Re : Proposed Landfill at Allawuna Farm Lots 9926, 4869, 5931 & 26934 Great Southern Highway York

Please accept my submission to oppose the development of a Landfill Class 11 Facility on the above property and also to the Allawuna Farm Landfill Supplementary Report dated February 2015.

Figure 6

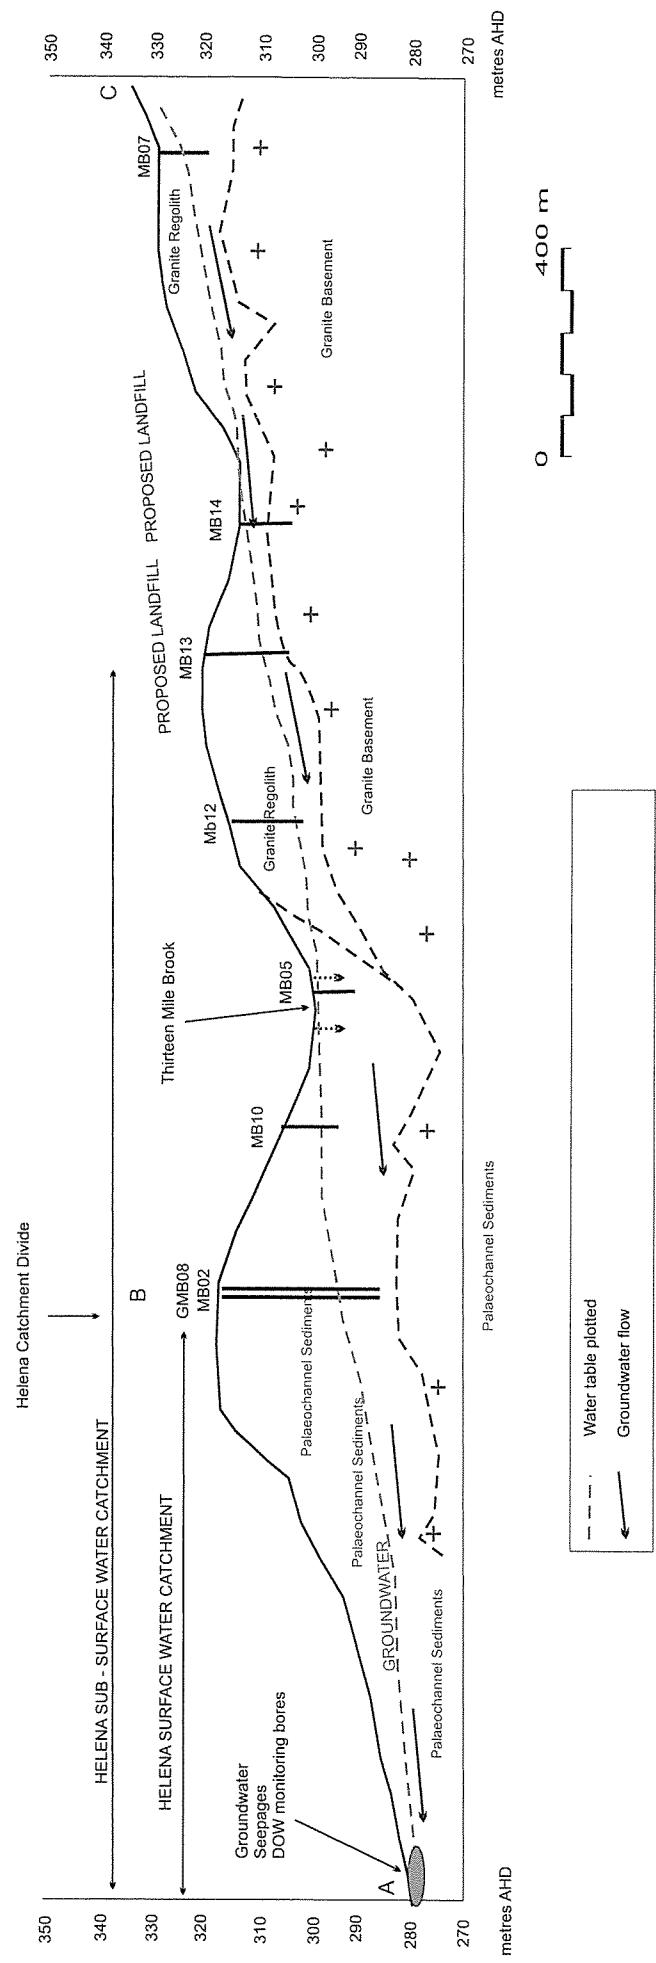
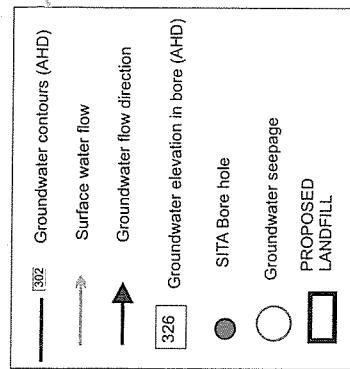
I can form no conclusion other than the section is an attempt to mislead. It is the only section submitted. There is no real geological or hydrogeological section presented even though there is detailed geology and drilling. I prepared sections in March 2014 and these have been confirmed by the drilling conducted by Golder. My updated section is attached as Figure 6.

Water table elevations are taken as the standing water level in the SITA bore hole logs and monitoring data.

The location of the bores was plotted using SITA data because the data west of Thirteen Mile Brook was excluded in the published topographic maps.

GROUNDWATER FLOW TO THE
HELENA CATCHMENT IS PROVEN
WHEN THE MISSING WESTERN
BORE DATA IS ADDED

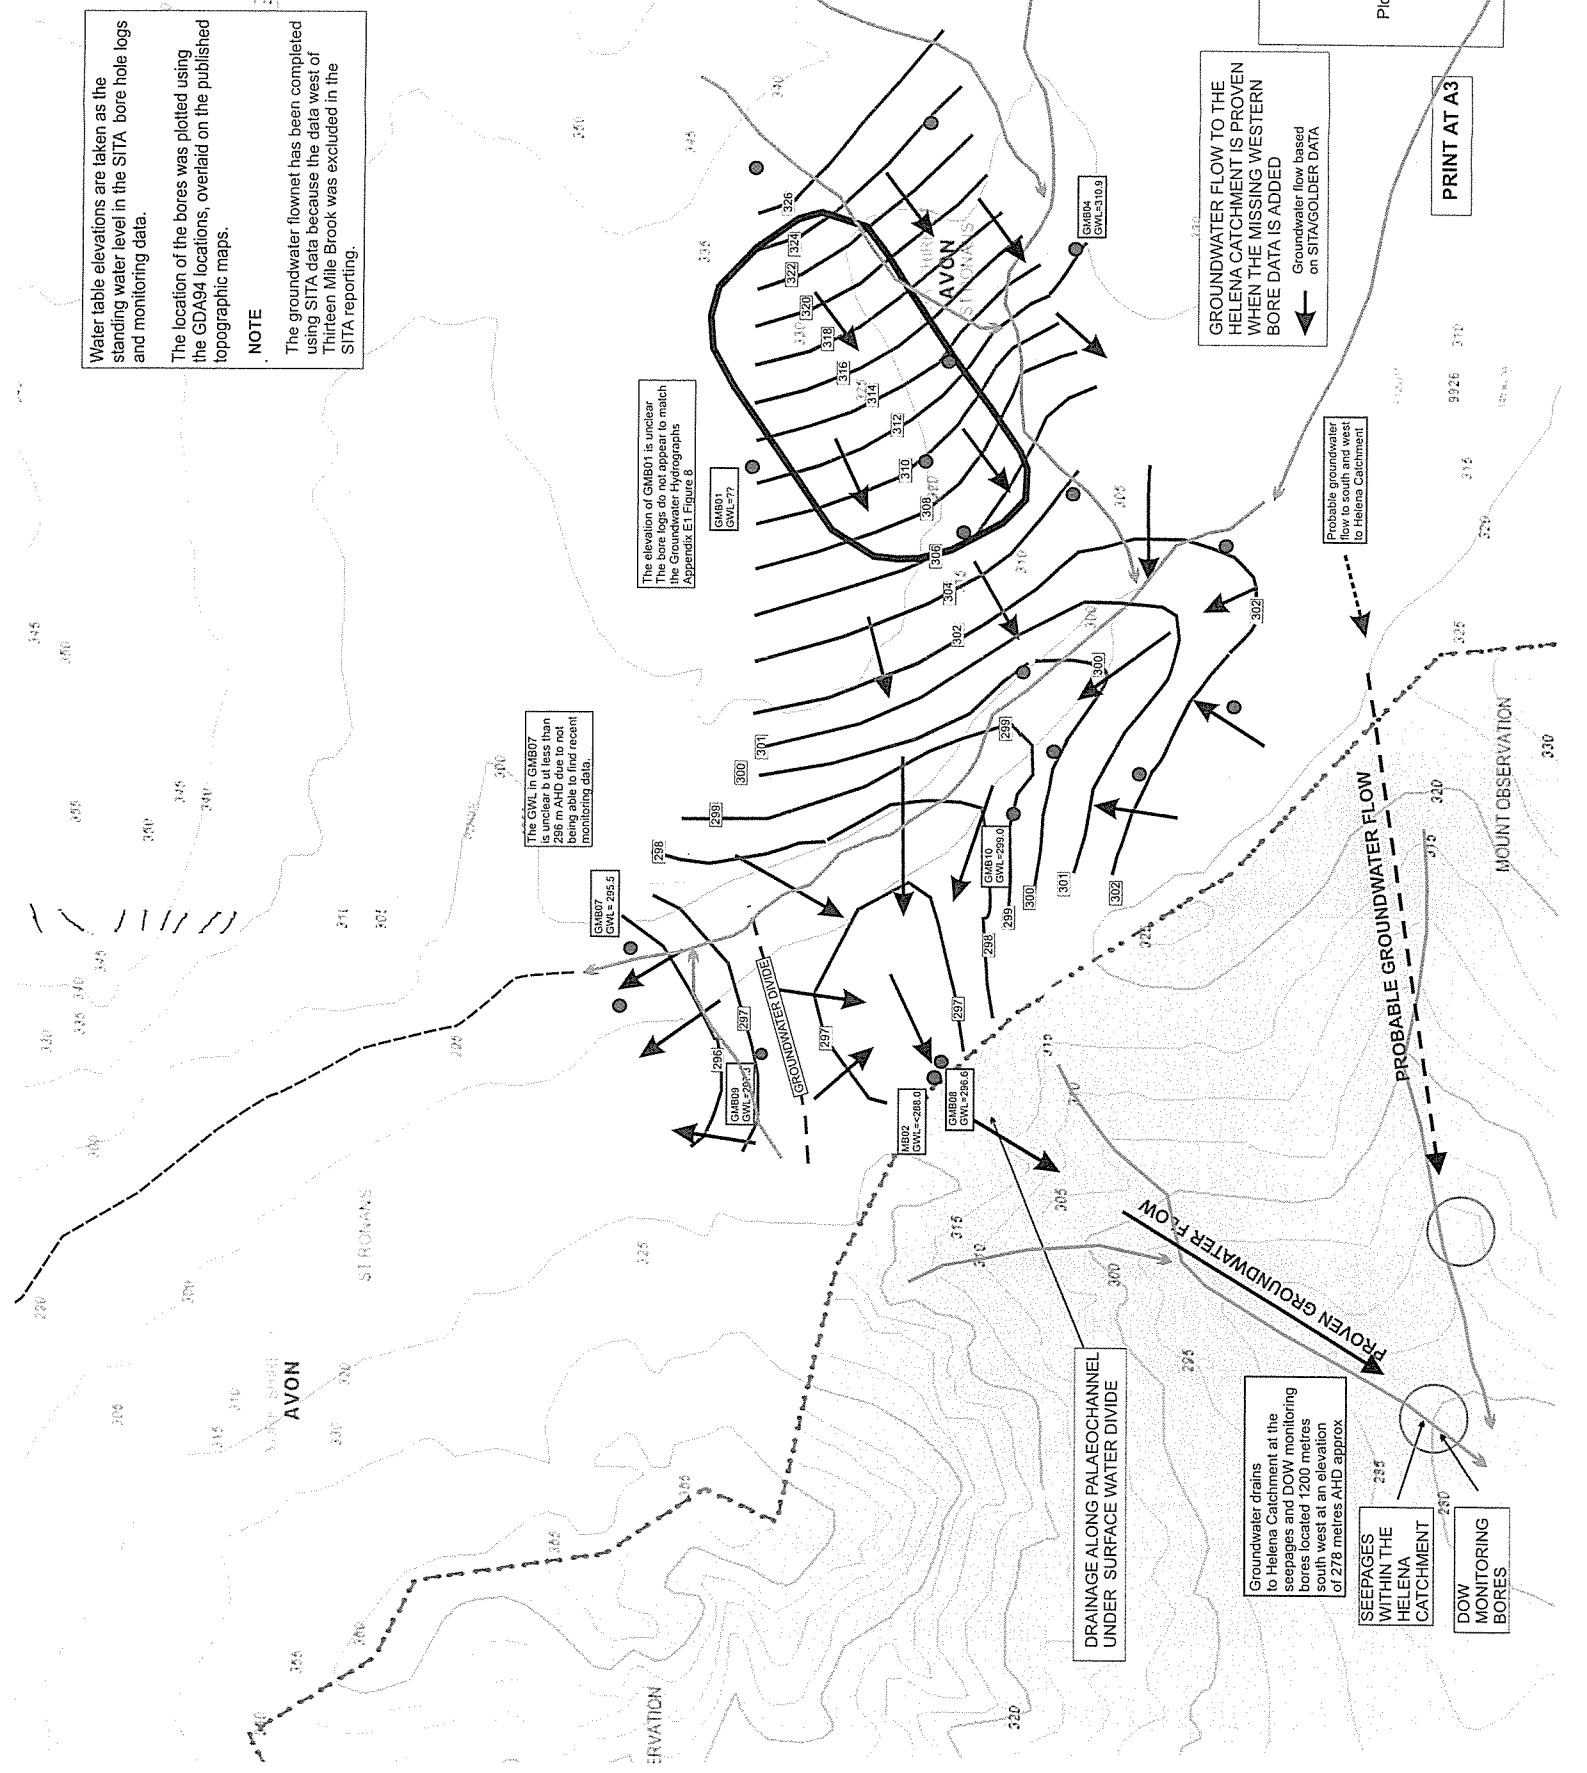
Groundwater flow based
on SITA/GOLDER DATA

Probable groundwater
flow to south and west
to Helena Catchment

DRAINED ALONG PALEOCHANNEL
UNDER SURFACE WATER DIVIDE

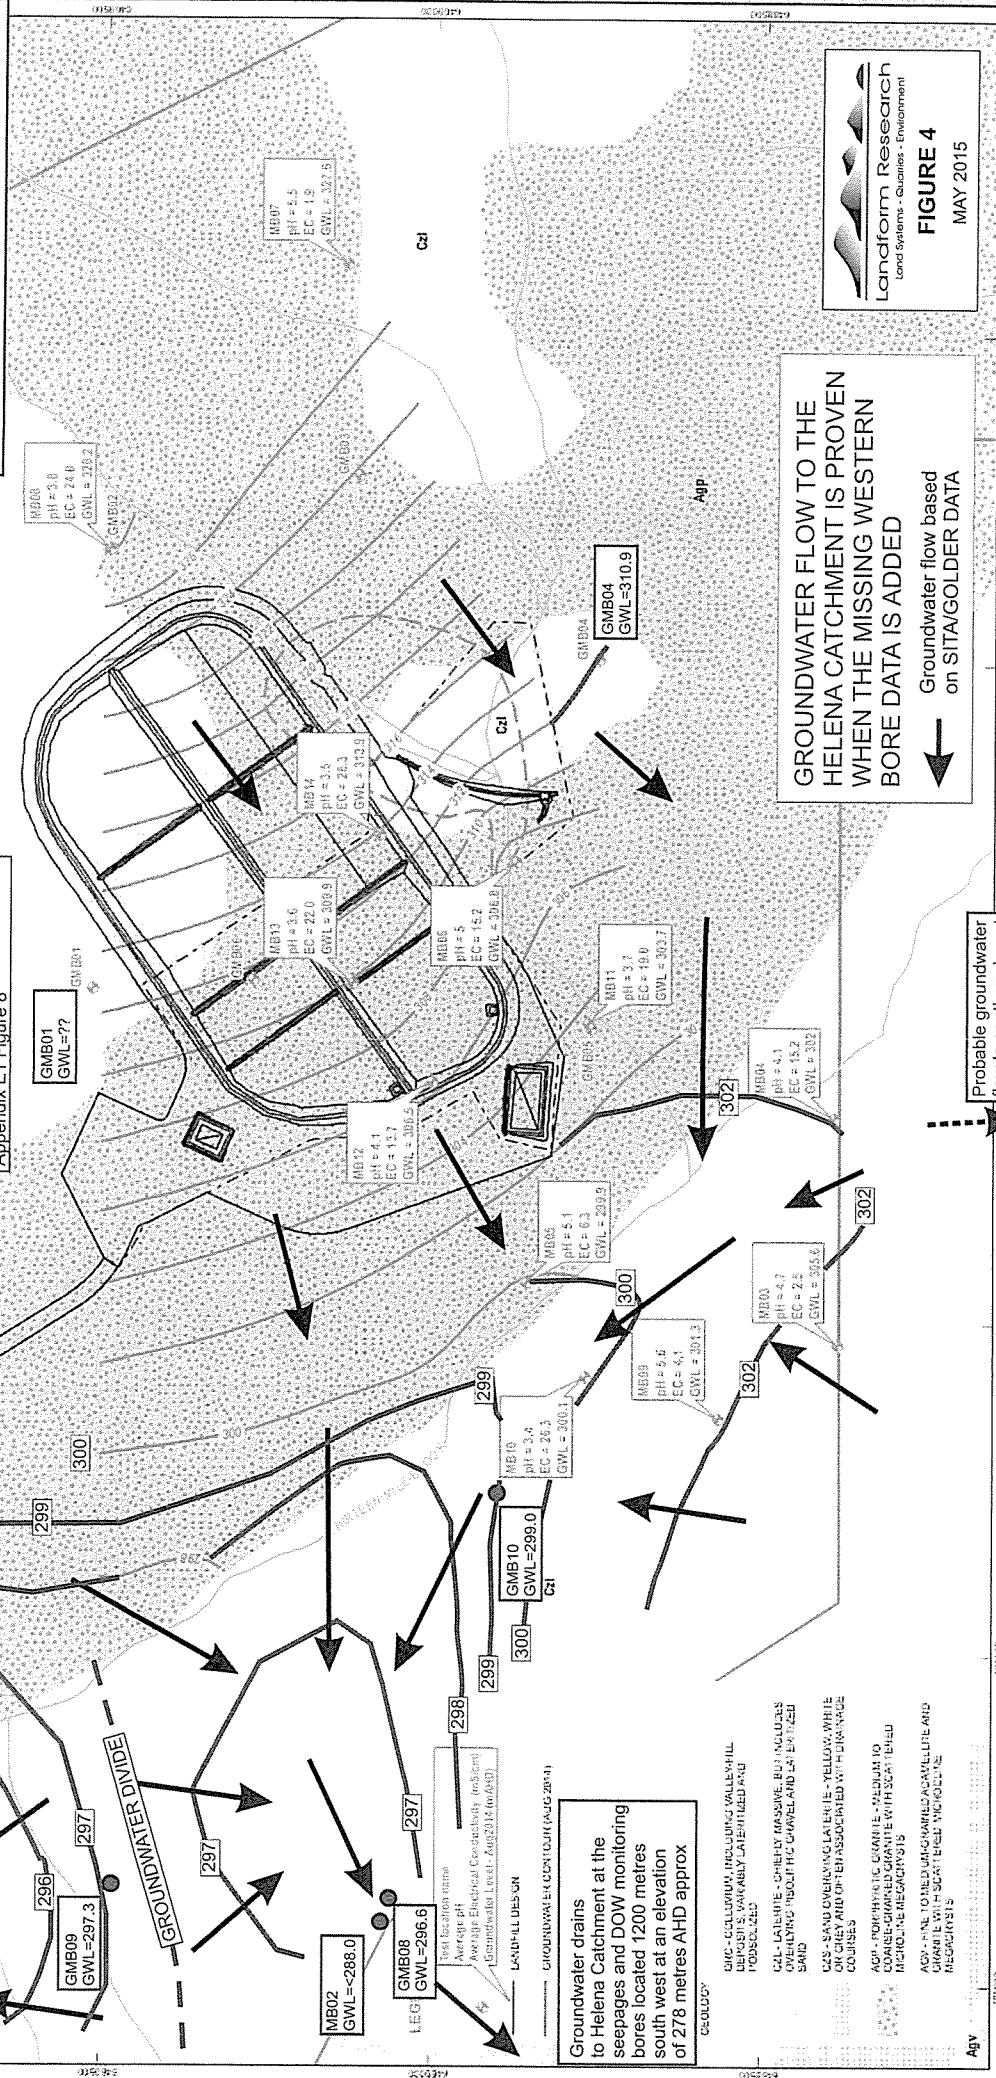
THE DATE OF THE GOLDER PLAN PREDATES THE DRILLING OF HOLES GMB01 - GMB10 WHICH ARE EXCLUDED.

NO DATA WEST OF THIRTEEN MILE BROOK IS INCLUDED BY GOLDER.

THIS PLAN SIMPLY ADDS THE GOLDER DATA THAT IS MISSING
